Re: Proposed Modification--Kiln 2 Coal Conversion  
PSD-FL-142 - AC13-169901

This correspondence provides responses to the Department's completeness letter dated October 4, 1989, concerning the above-referenced permit application. Each topic described in the EPA's draft comment letter dated October 3, 1989 is addressed in the attached response. In addition, the Department's comment concerning an air quality analysis for the Biscayne National Monument is addressed. Two sets of supportive computer printouts and computer disks are included.

**TARMAC  
KILN 2 COAL CONVERSION  
RESPONSES TO FDER/EPA COMMENTS  
NOVEMBER 1989**

Figure C-1 BUILDING DOWNWASH ANALYSIS FOR KILN NO. 2

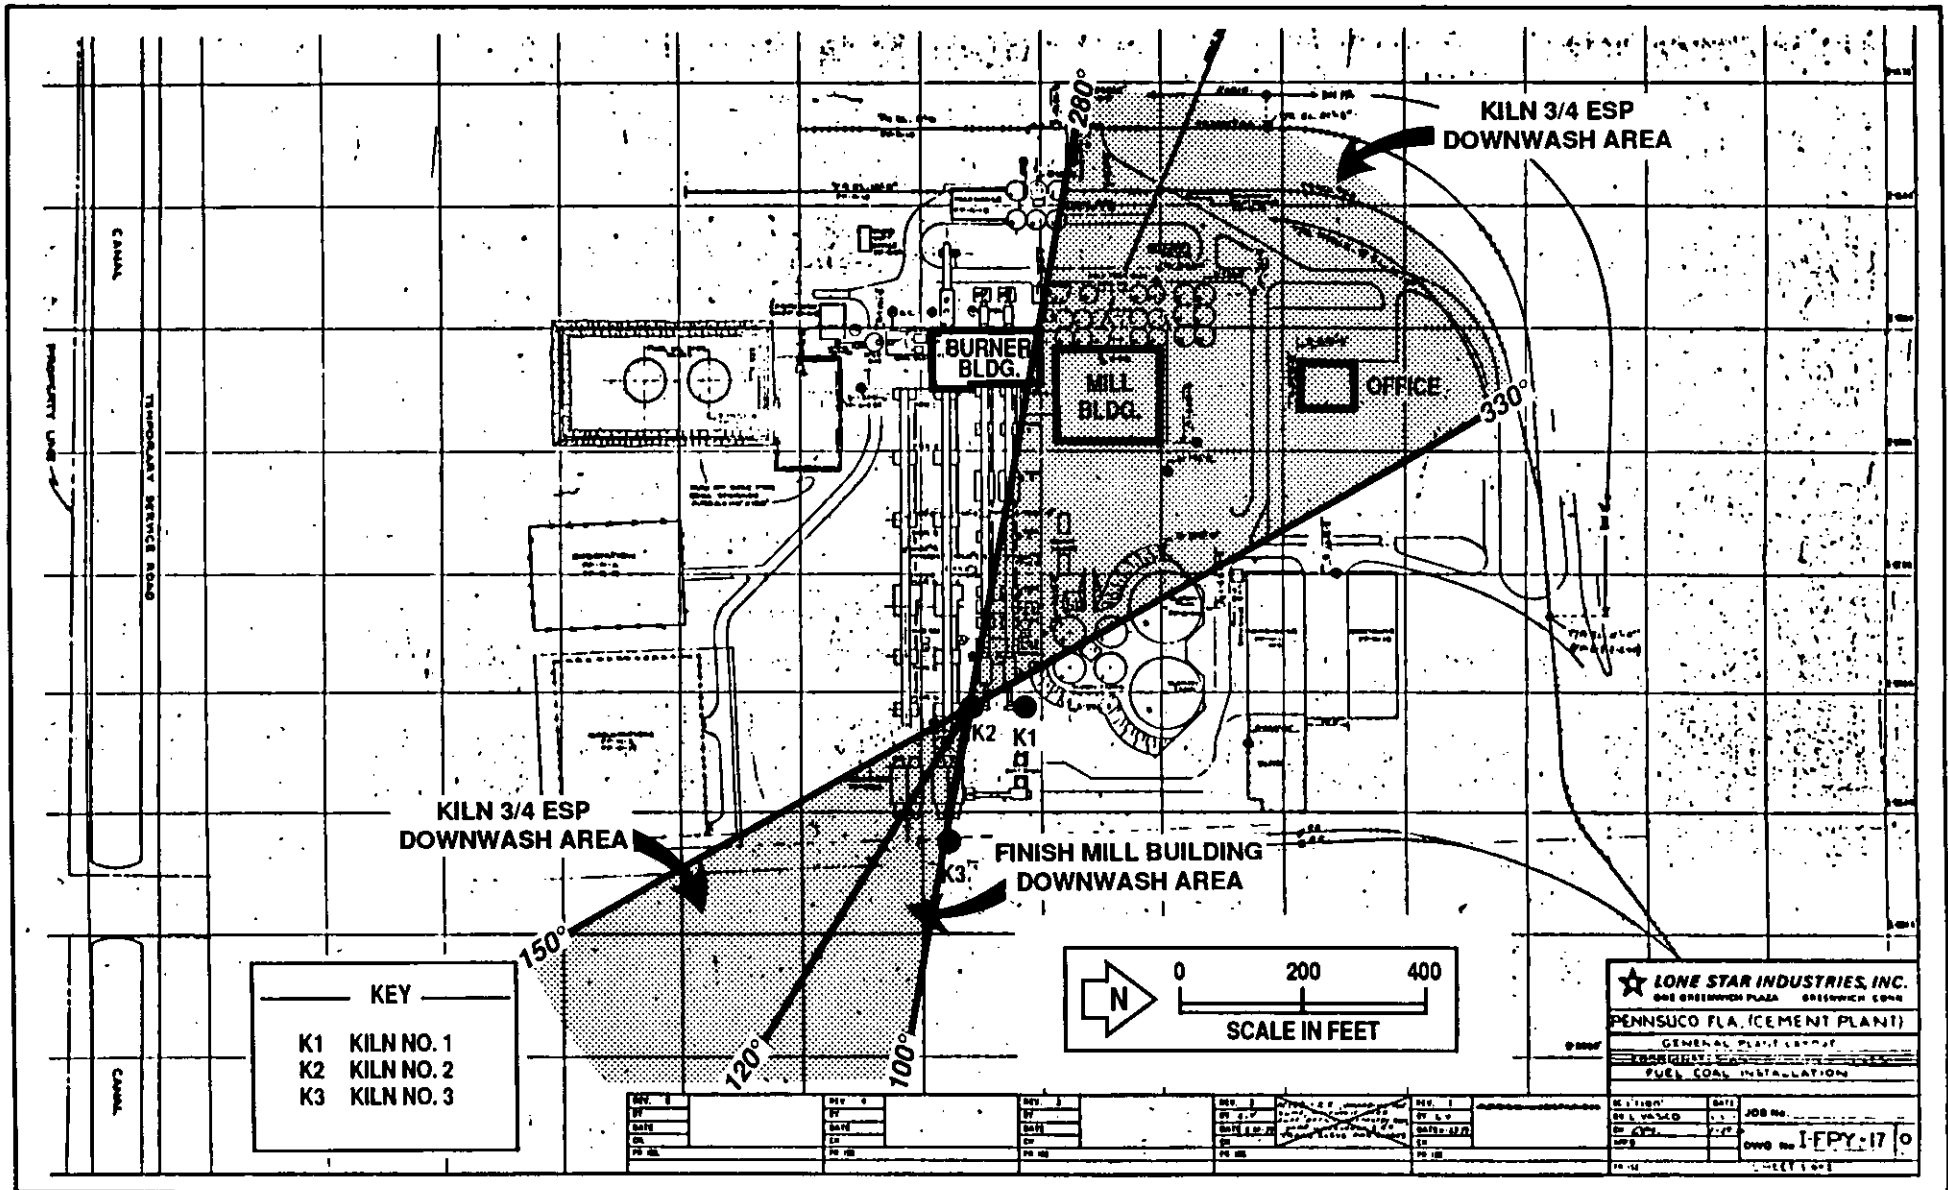
The effects of building downwash from structures at the Tarmac facility on predicted SO<sub>2</sub> impacts were considered. The most significant structures at the Tarmac facility are the finish mill building, the kiln burner building, Kiln 1 and 2 ESPs, and Kiln 3 and 4 ESPs. As stated in the PSD application, the kiln burner building and Kiln 1 and 2 ESPs are not tall enough to influence plume dispersion from any of the kilns. However, potential downwash could occur due to the finish mill building and Kiln 3 and 4 ESPs, since the stacks for Kilns 1, 2, and 3 are less than Good Engineering Practice (GEP) stack height for these structures. Source-building combinations and directions relative to the location of Kiln 2, in which building downwash is possible, are presented in the following table (also refer to Figure C-1.).

The Kiln 3 stack is downwashed in all directions, but Kiln 1 and Kiln 2 stacks are downwashed only in certain directions. The stacks for Kilns 1

and 2 are more than two building heights upwind from the finish mill building and, therefore, are only influenced downwind of this building in the 100° through 120° radial directions.

Figure C-2 PLOT PLAN AND PLANT PROPERTY BOUNDARY OF TARMAC FACILITY

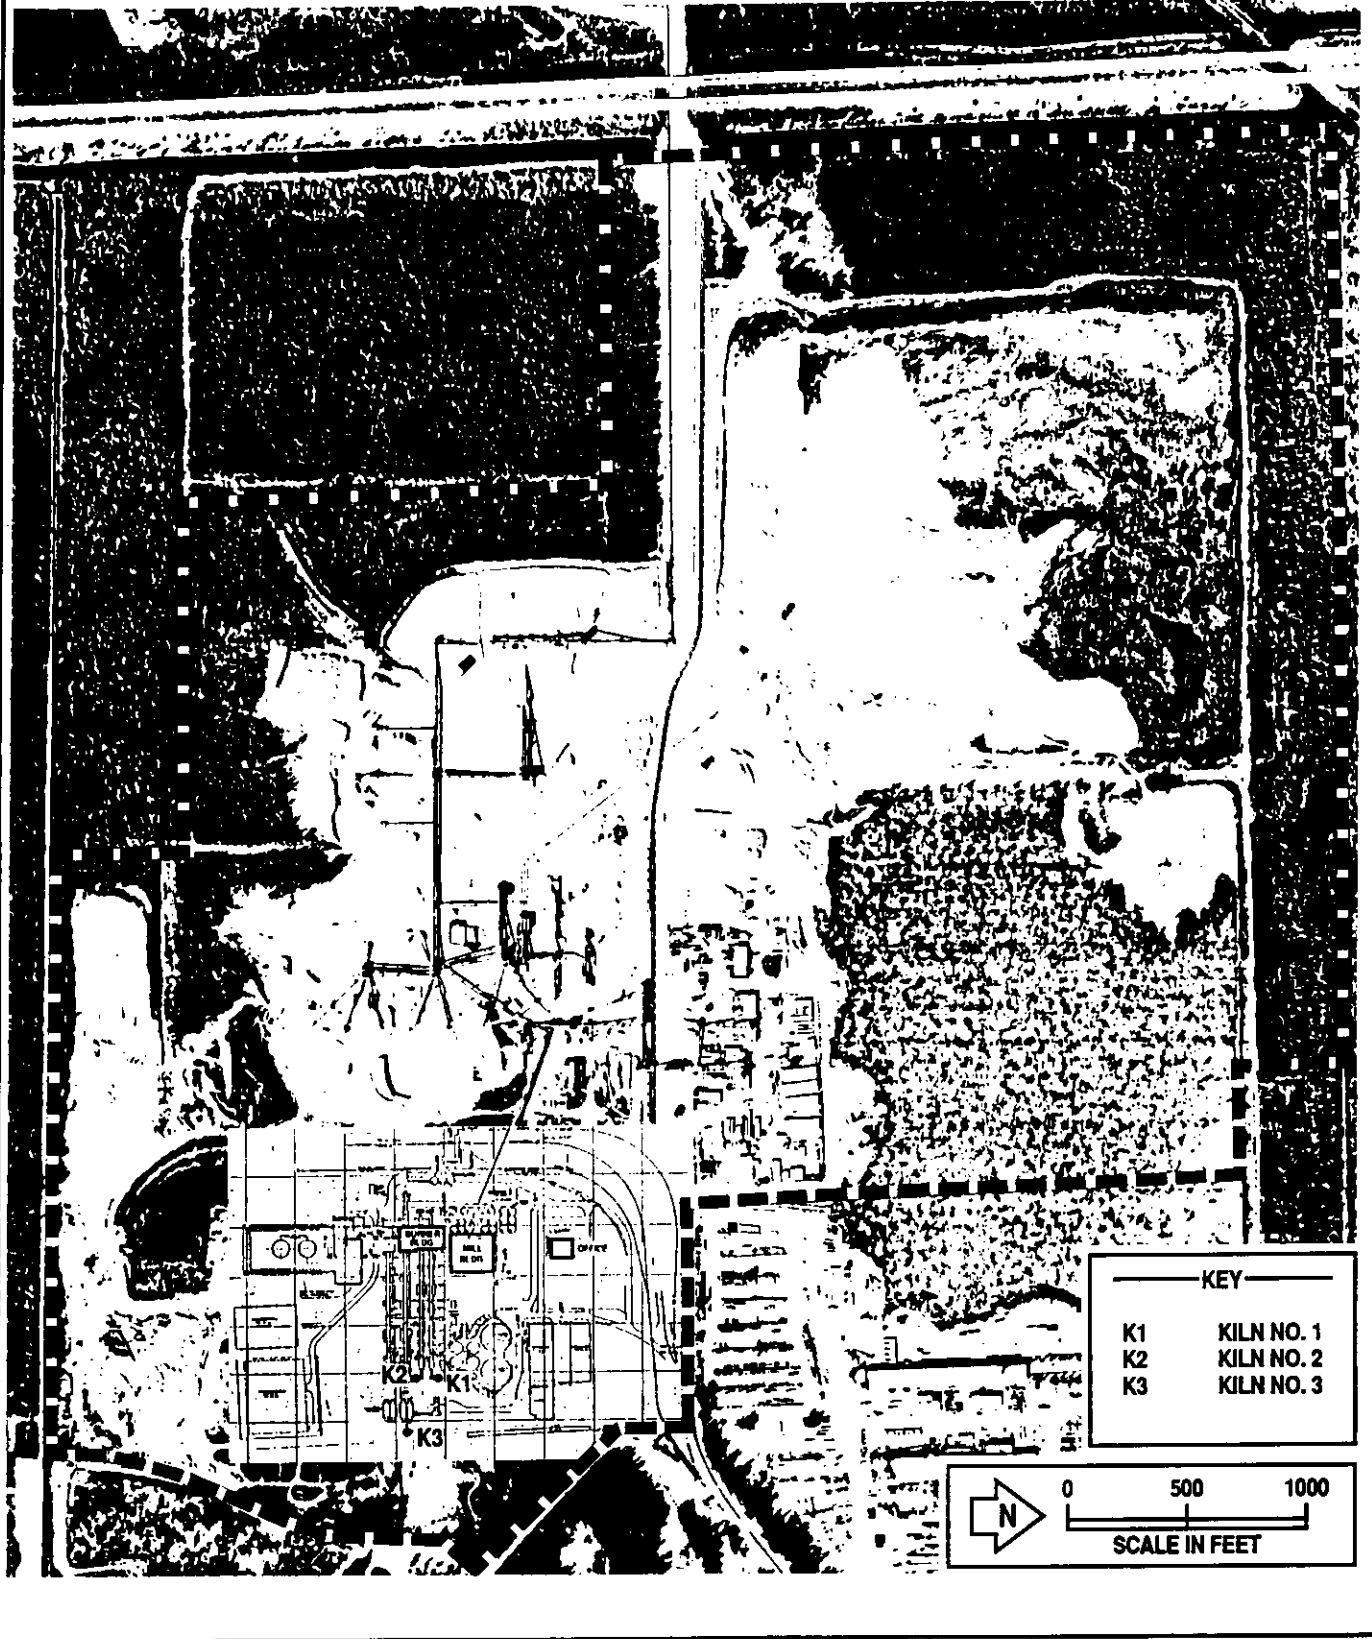
Impacts on plant property, previously reported in the PSD application, were eliminated from consideration. Only those impacts affecting ambient air (not on the limited access Tarmac property) were reported for comparison to PSD increments and AAQS. The extent of Tarmac's plant property is shown in Figure C-2. Distance and direction to plant property relative to Kiln 2 are presented in Table C-1. (Note that in Figure 2-2 of the application,

the north arrow was incorrectly oriented. Figures C-1 and C-2 are correct as shown.
